**ZONING AND PLATTING COMMISSION  
HILL COUNTRY SITE PLAN and ENVIRONMENTAL VARIANCE REQUEST  
REVIEW SHEET**

**CASE NUMBER:** SPC-2012-0429C    **COMMISSION DATE:** January 7, 2014

**PROJECT NAME:** Water Control and Improvement District No. 17-Mansfield Water Treatment Plant

ADMINISTRATION/MEMBRANE FILTER BUILDING  
HEIGHT CROSS SECTION A

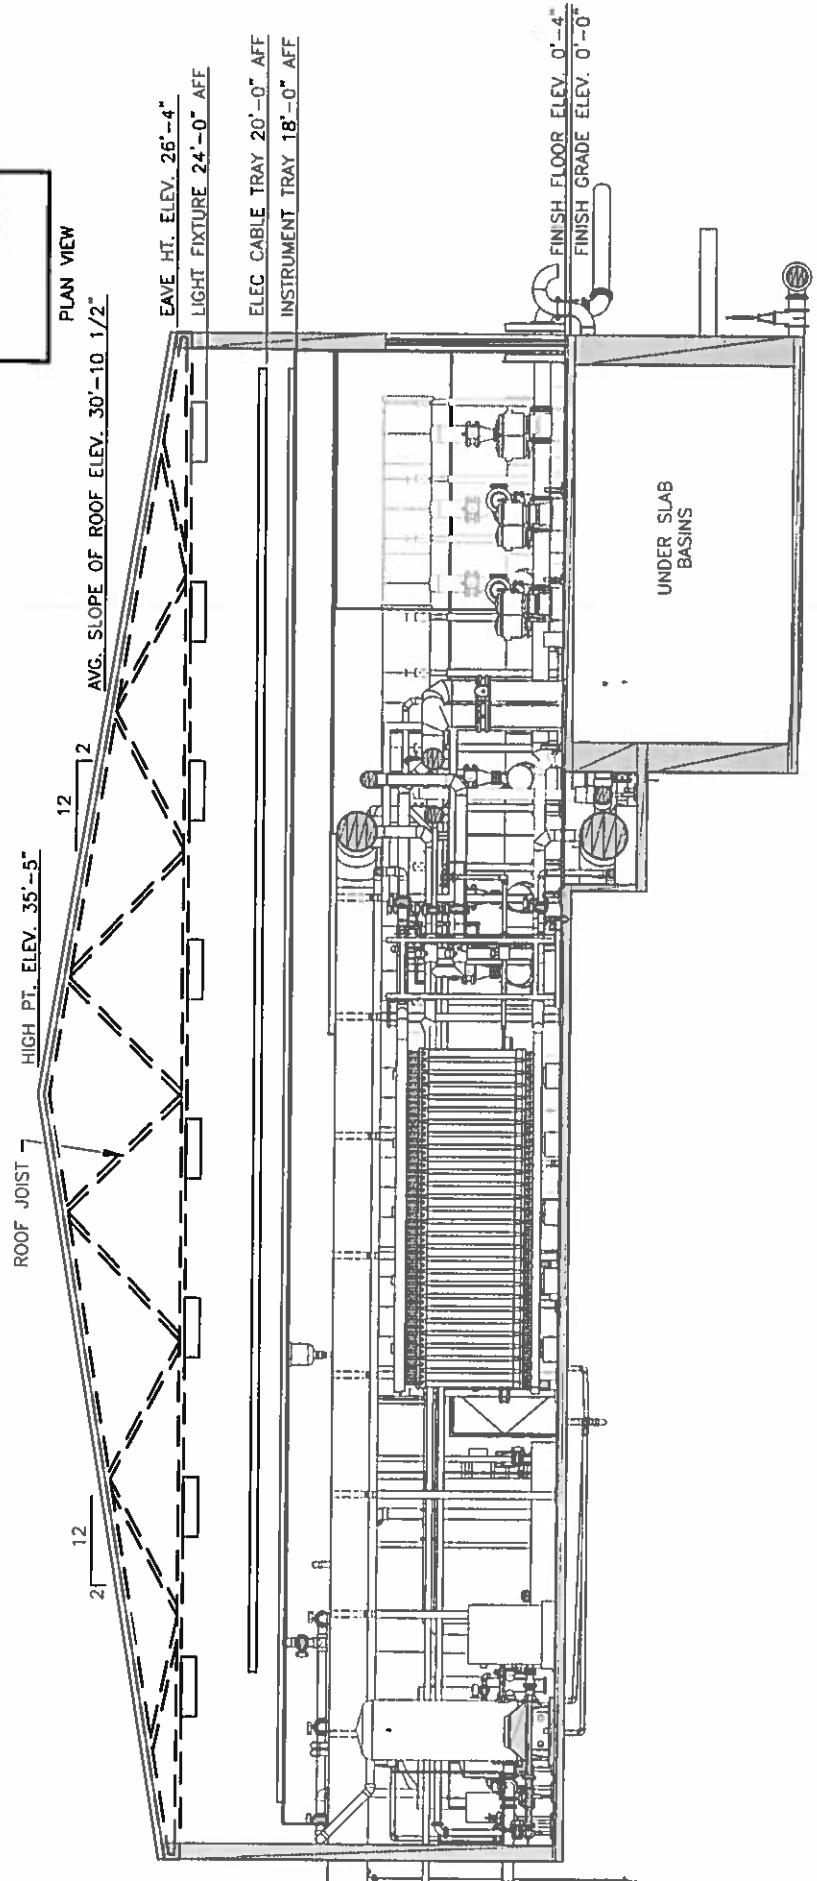
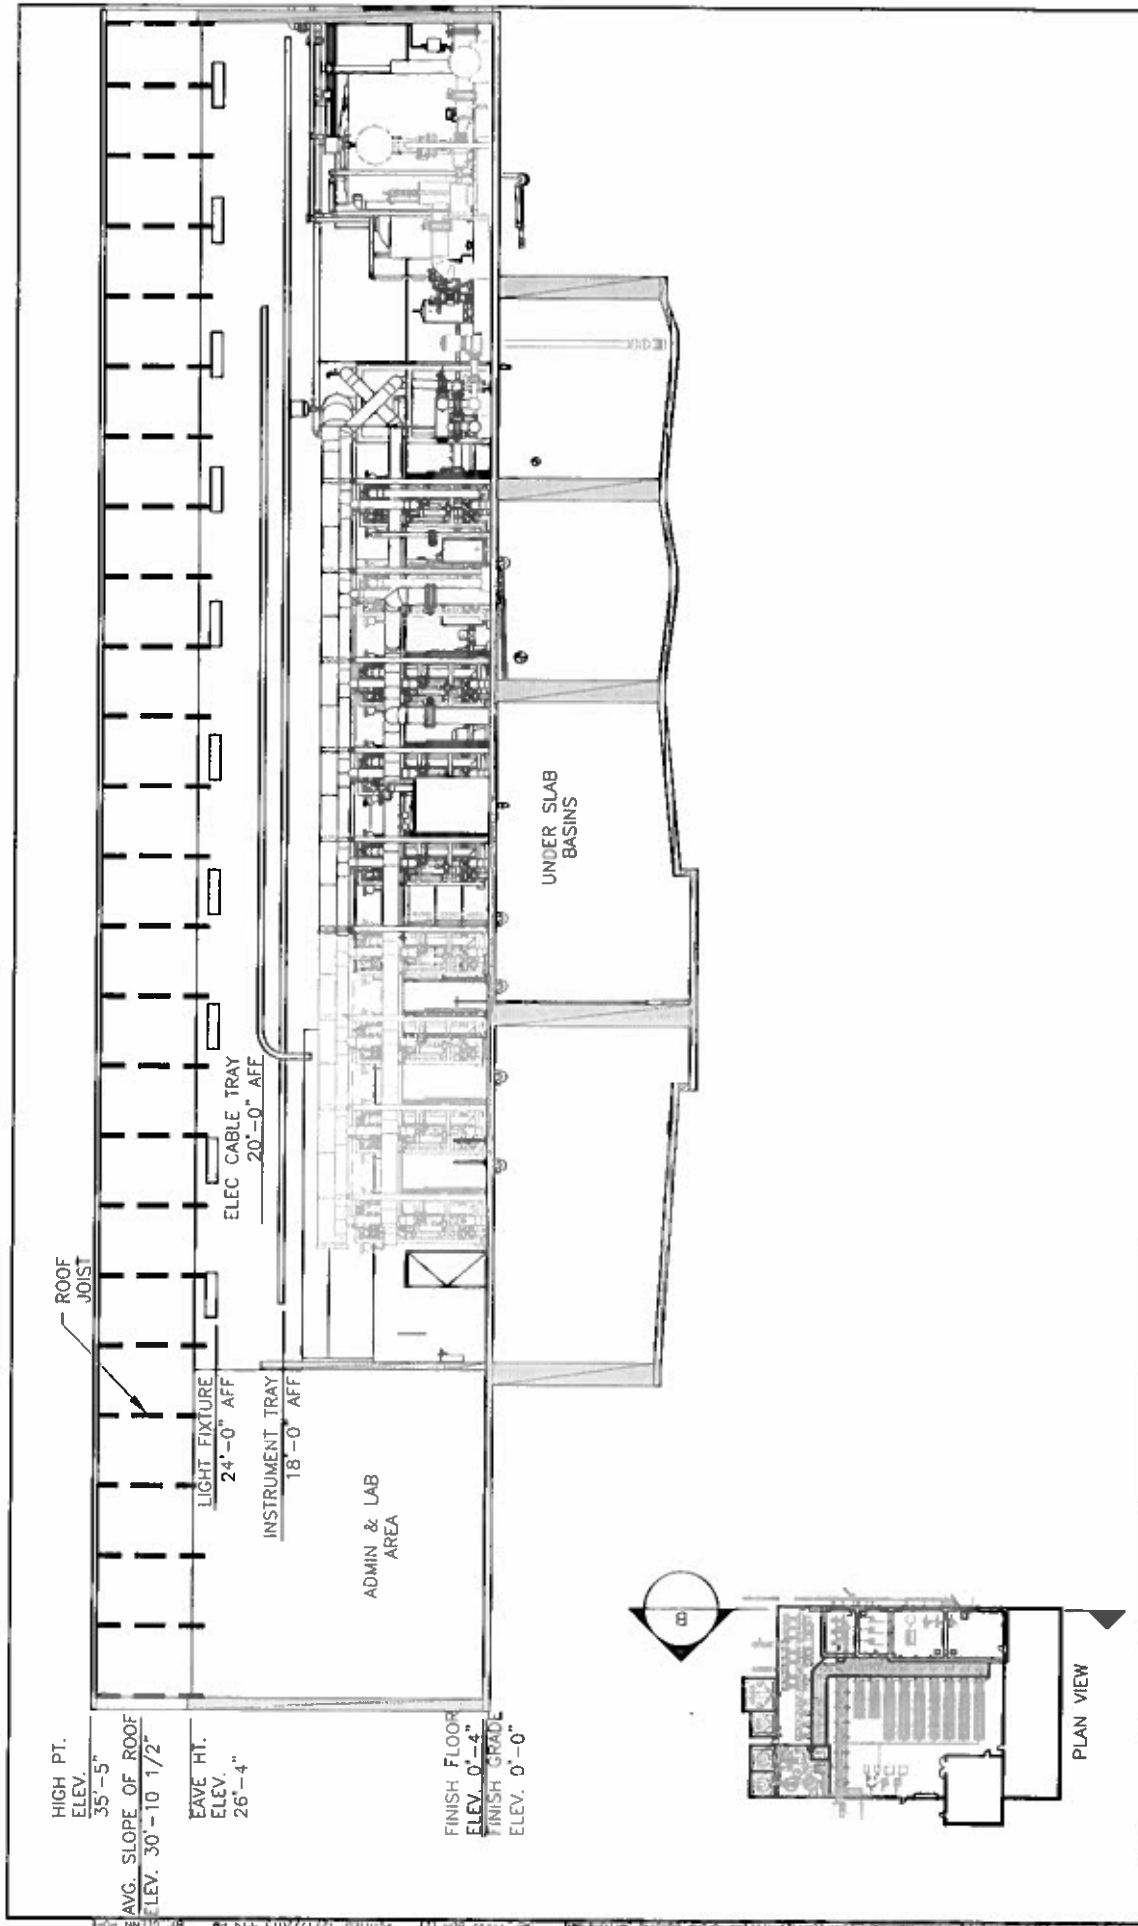
Travis County W.C.&I.D. No. 17 is requesting a waiver to §25-2-1124 of *The Code of the City of Austin*, which states that a person may not construct a building that is more than 28 feet in height if the building is 200 feet or less from the nearest Right-of-Way boundary of a hill country roadway or in a low intensity zone. This project proposes to construct the Water Treatment Plant's main Membrane and Lab Building at a height of 30-feet, 10 1/2-inches, see attached Administration/Membrane Filter Building Height Cross Section exhibits.

- There are specific operational, equipment, structural, space, and layout needs with the design of a membrane water treatment plant that dictate building height requirements. The District's Water Treatment Plant main Membrane and Lab building maximizes these design requirements, see attached Administration/Membrane Filter Building Height Cross Section exhibits. The building materials (painted concrete tilt walls) and roof design (sloped standing seam metal roof system with galvalume coated finish) that are being implemented have been carefully chosen to protect the water treatment equipment, chemicals and finished drinking water from contamination by the elements and public.

**SUMMARY STAFF RECOMMENDATION FOR HCRC SITE PLAN:** Staff recommends approval of this Hill Country Roadway site plan. Staff recommends approval of the Hill Country Roadway waivers to allow an increase of building height from 28' to 30' 10 ½" and to reduce the natural area from 40% to 21%.
